Parks Commission

City of South Haven

Dyckman Beach Access

Kid's Corner Play Structure

Dyckman Access
ENTRY TREATMENT - OPTION C
SCALE: 1" = 10'

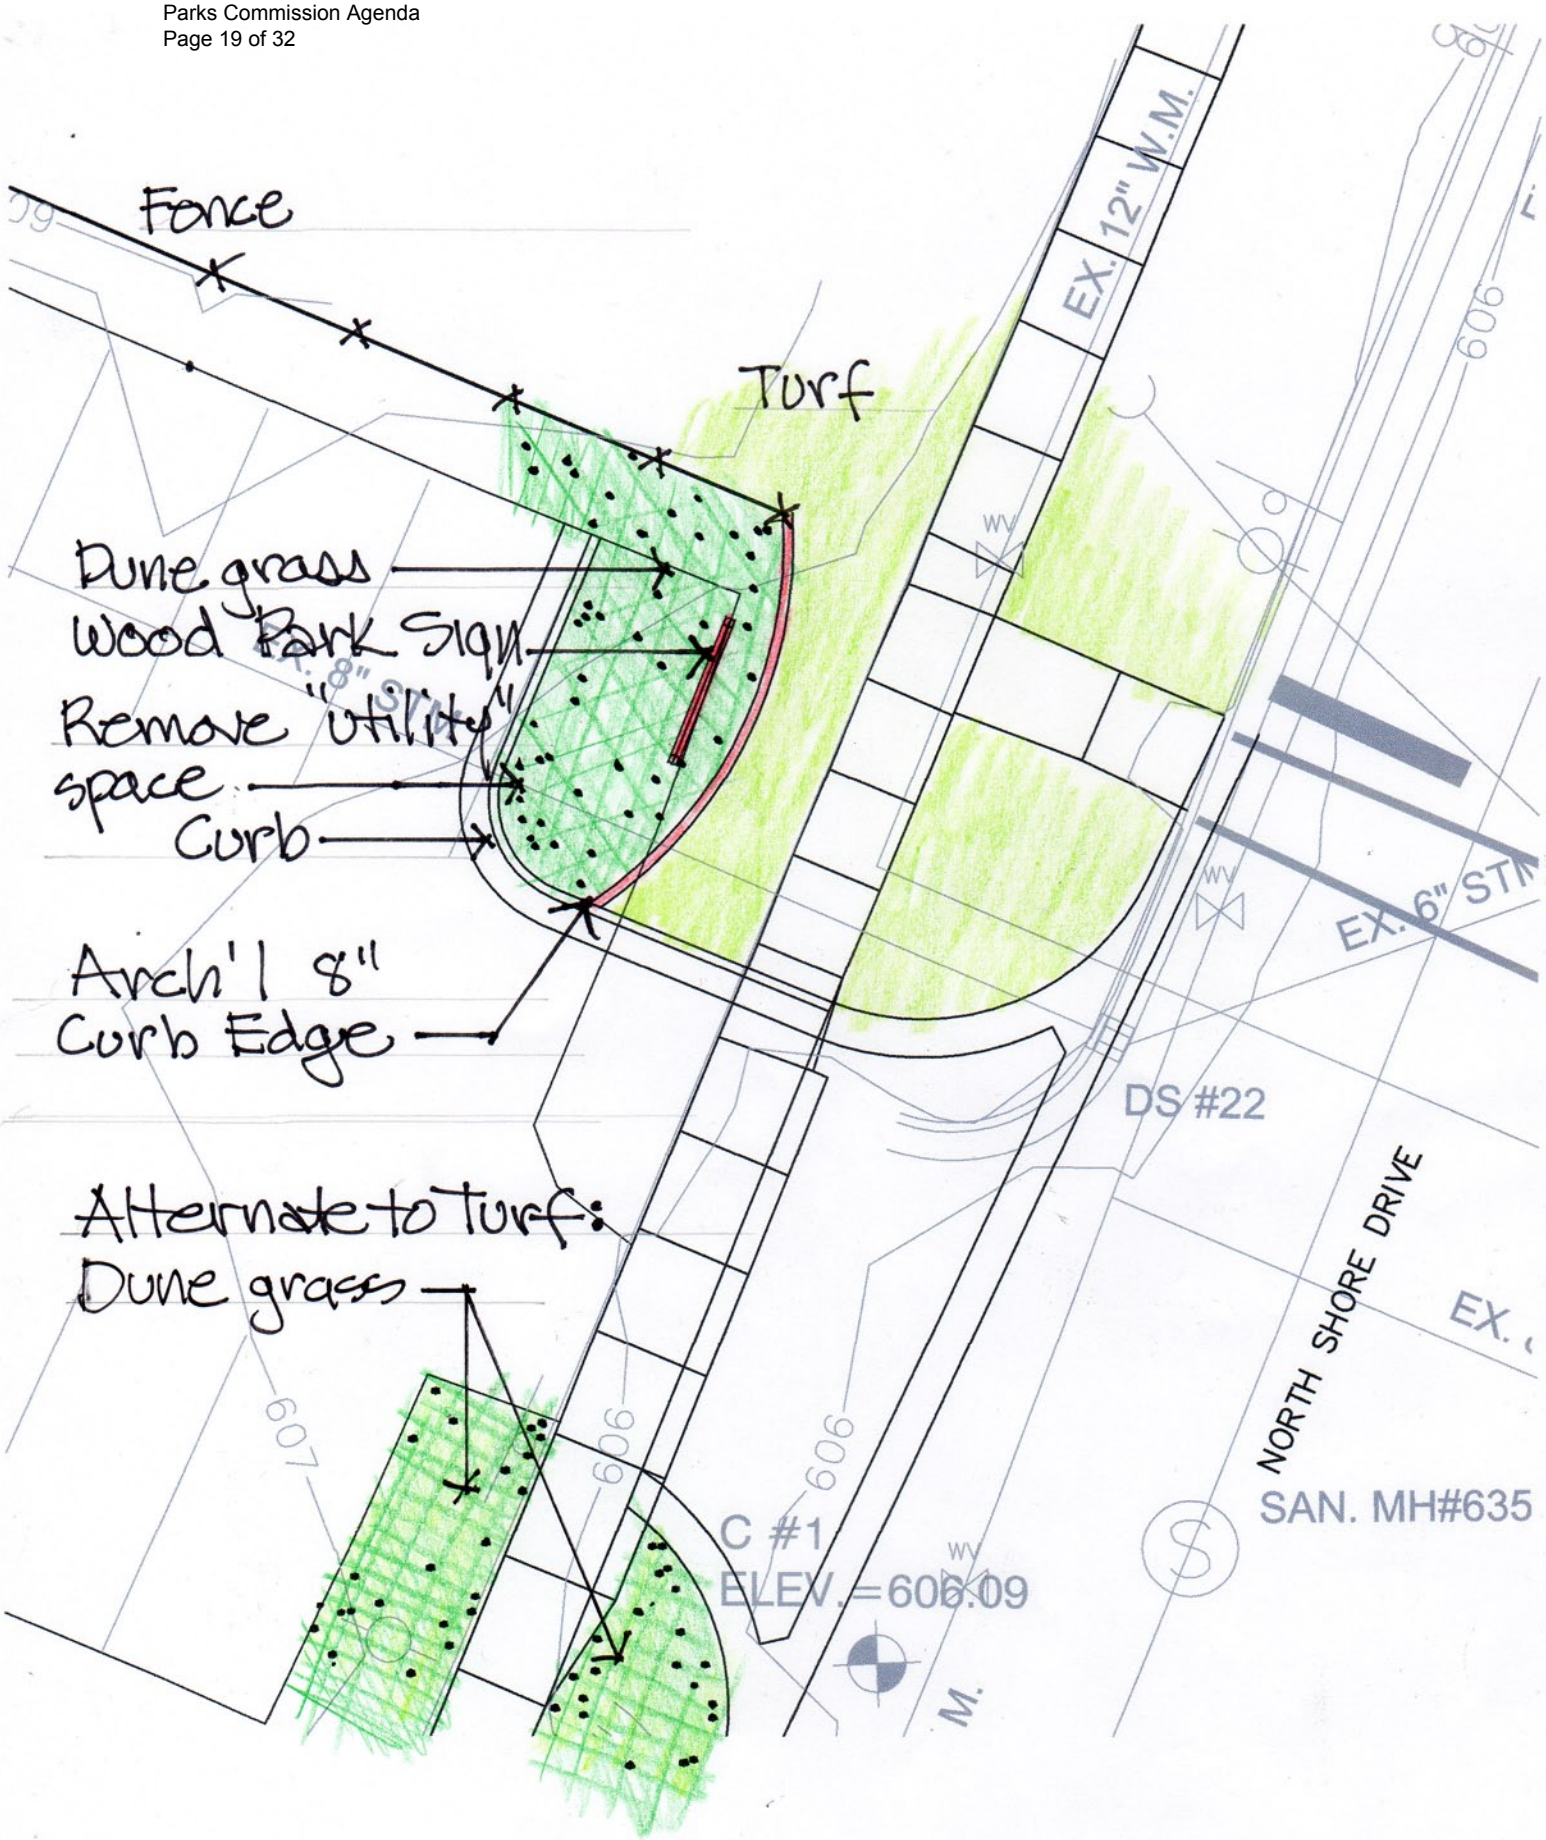
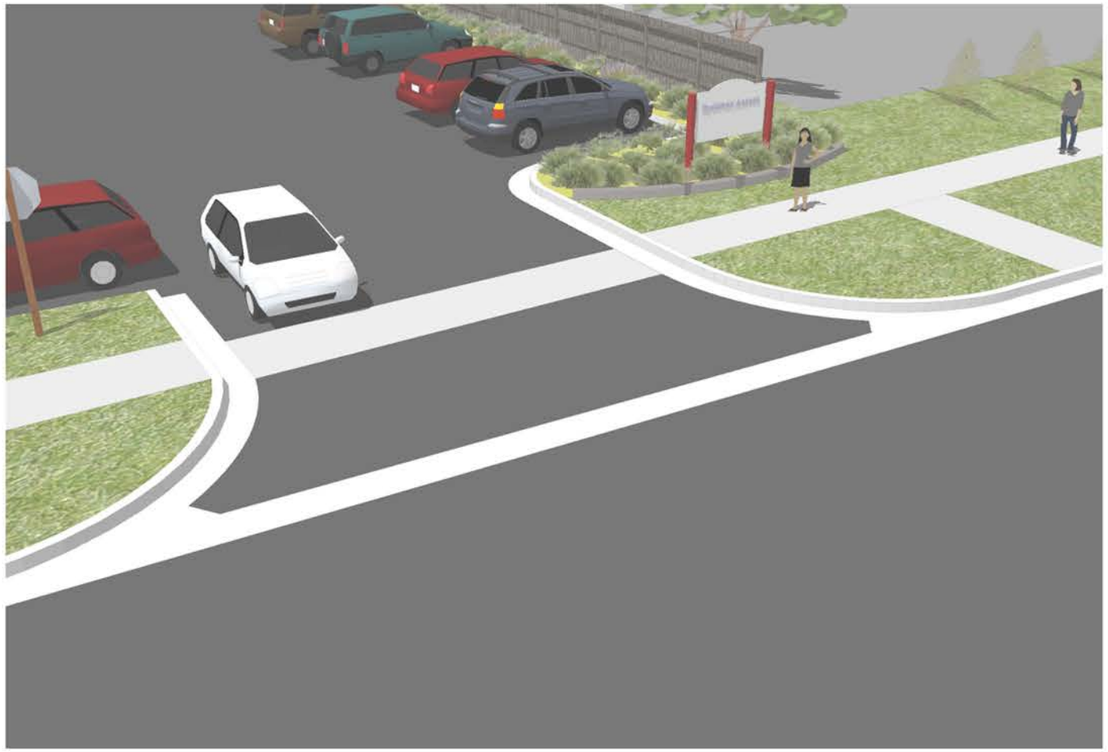
I am also opposed to Option C & D because of the height and width of the sign, which will block the view of the water.

LONG TIRE CLIMBER REPLACEMENT

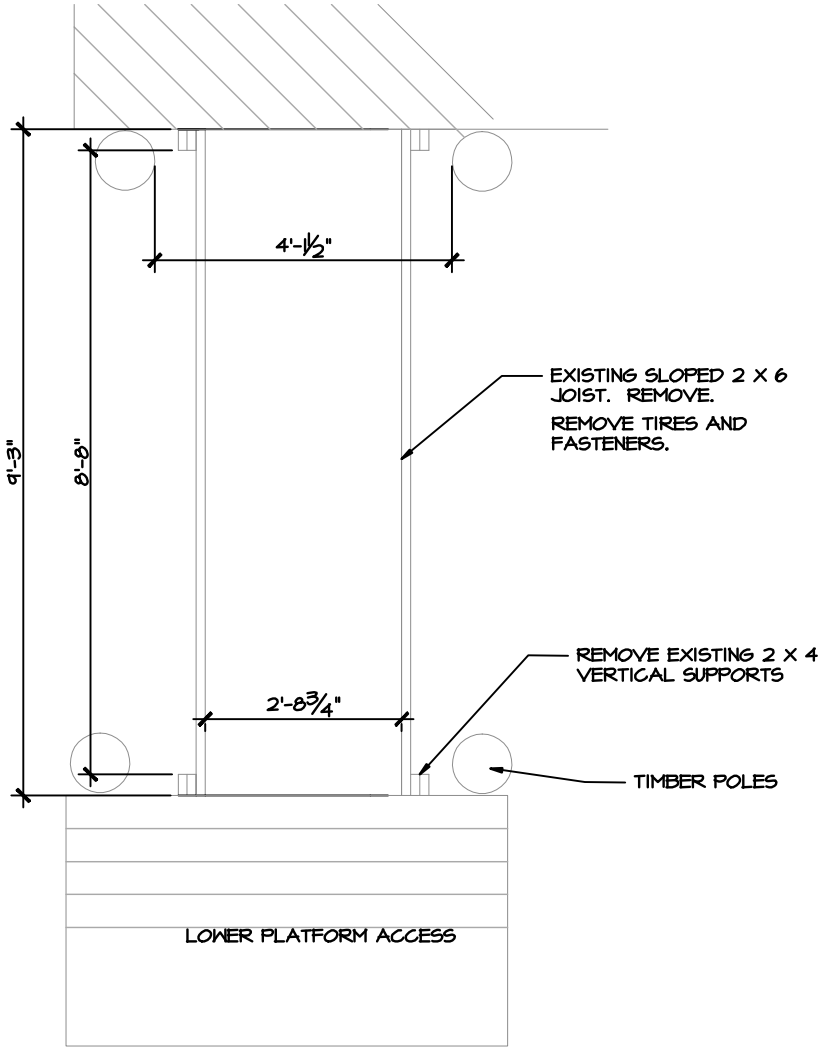
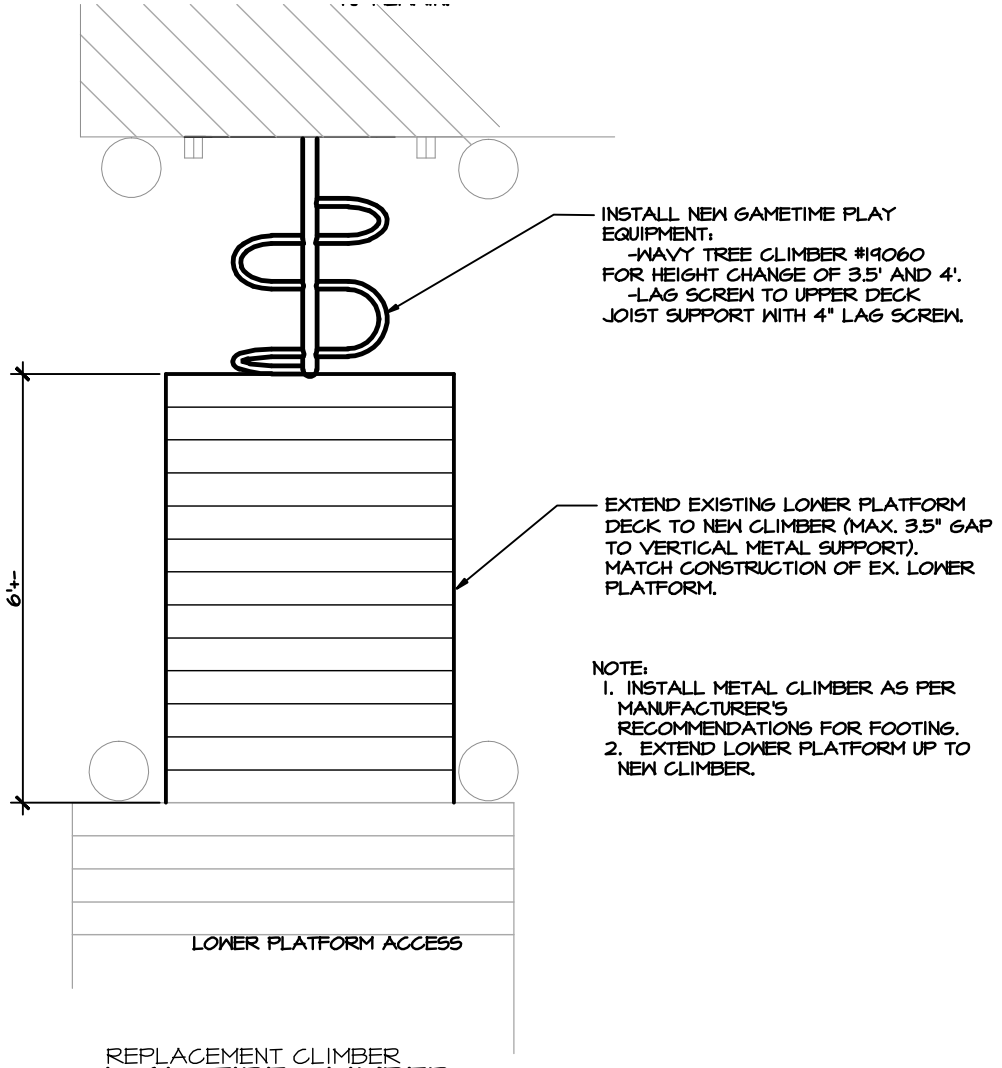
Several of the features are tire climbers, which utilize recycled tires to transition between platforms on the structure. This spring, a smaller child was attempting to traverse down the long tire climber and tripped. The fall left the child dangling from one of the tires with their head stuck. City staff has responded to this incident by filling the inside of the tires with plastic drain tubing. This prevents a similar incident from occurring.

Due to these reasons, the City may want to consider replacing the long and short tire climbers on the Kid's Corner Play Structure. The attached documents show potential modifications that could be made to replace the two tire climbers. The long tire climber (four tires) would be replaced with a platform extension and a Wavy Tree Climber from Game Time. The attached sketch shows the short tire climber being replaced with timber steps. This is one potential alternative. Other options include a rope climber or constructing a timber climbing wall with handholds. A low tire feature would remain in place.
